## MAIR300 Series Product Catalog Change Notification

MAIR300 series

MAIR300 series Catalog :

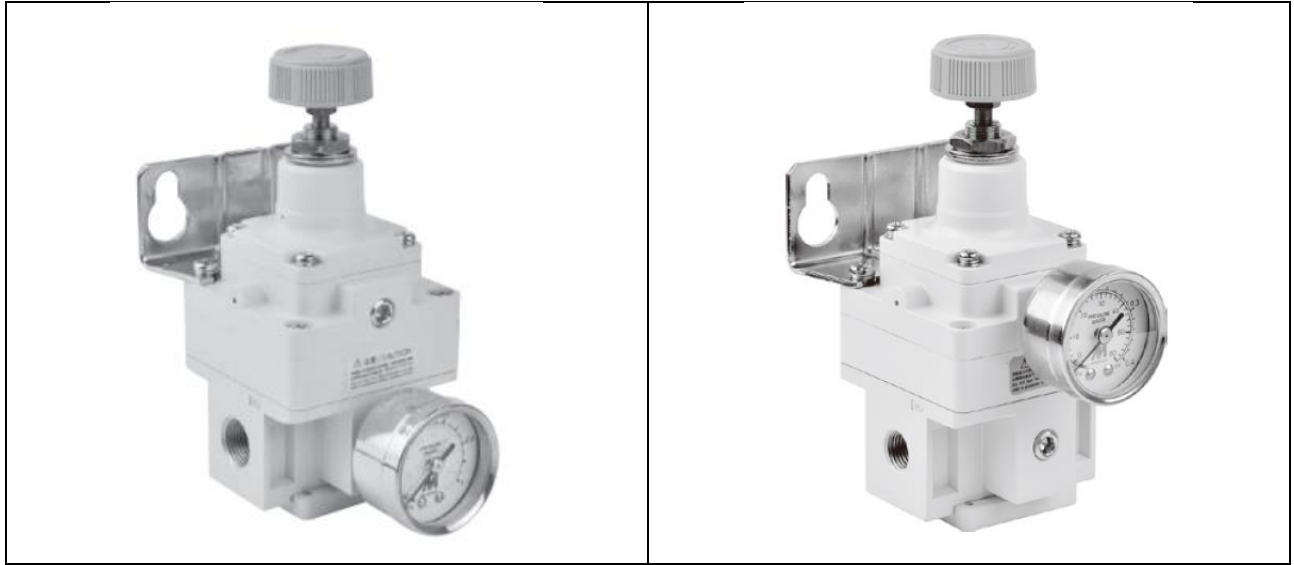
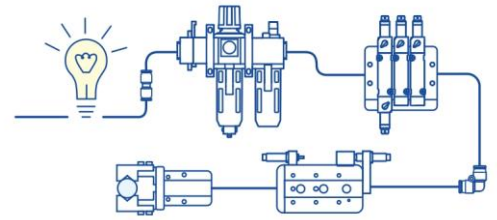
The mark of catalog is wrong. Therefore, we correct the error.

Please install the pressure gauge in the upper pressure gauge port, and seal the 1/8 thread of lower port with a plug.
